**FLOWER CHILD**  
1900 CROCKER ROAD  
WESTLAKE, OH 44145

Drawing No: 26-0313-R01

Page No: SP1.01

1 SITE PLAN  
SCALE: NTS

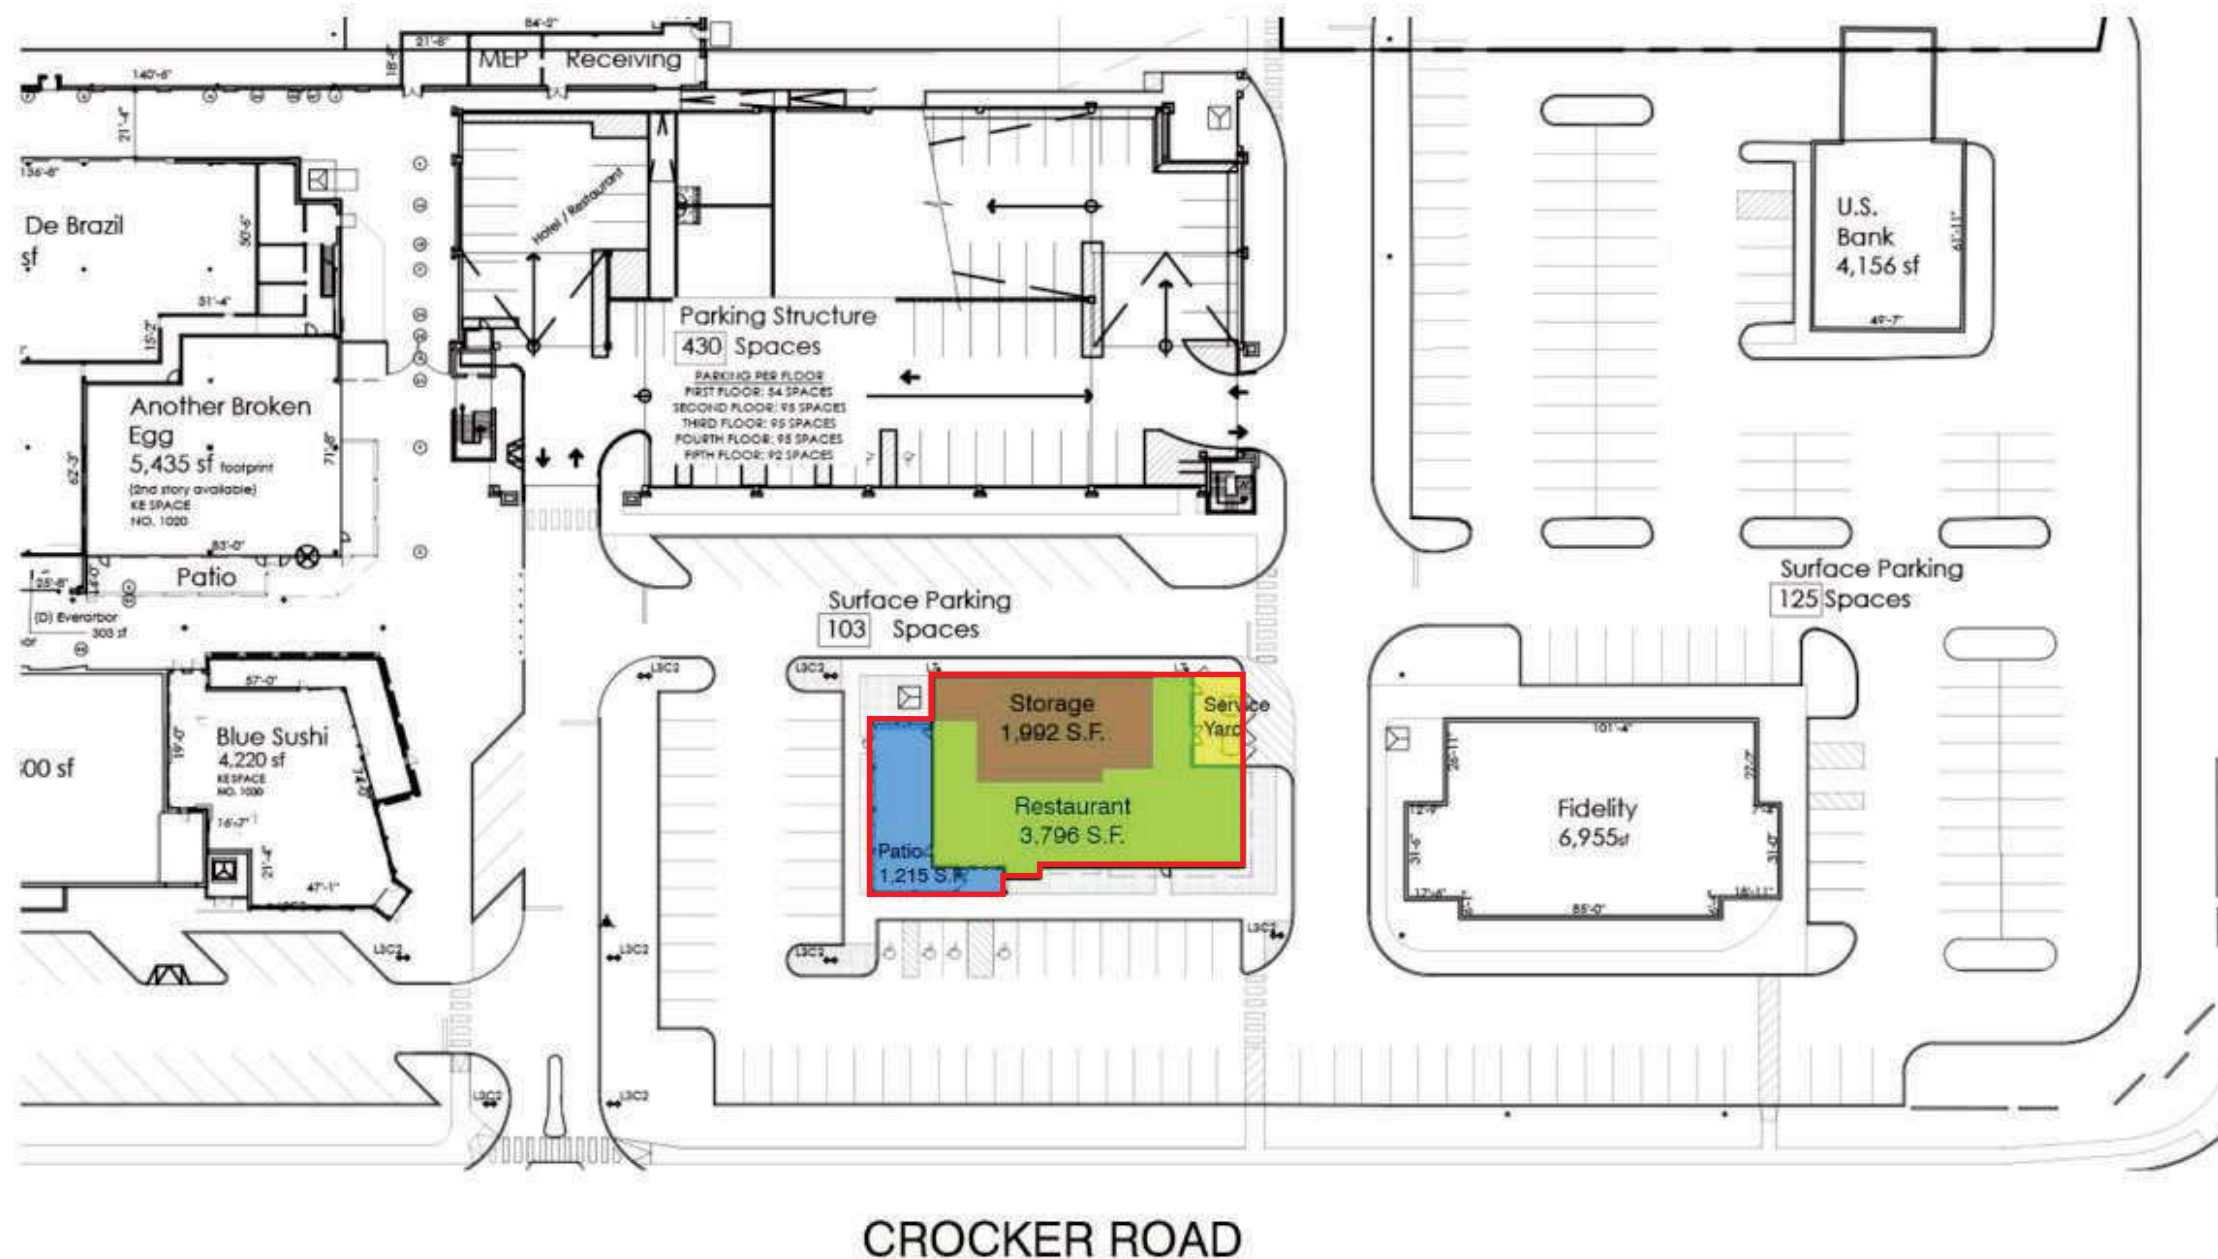
1) PM-08.07.26: Update C/D to painted letters
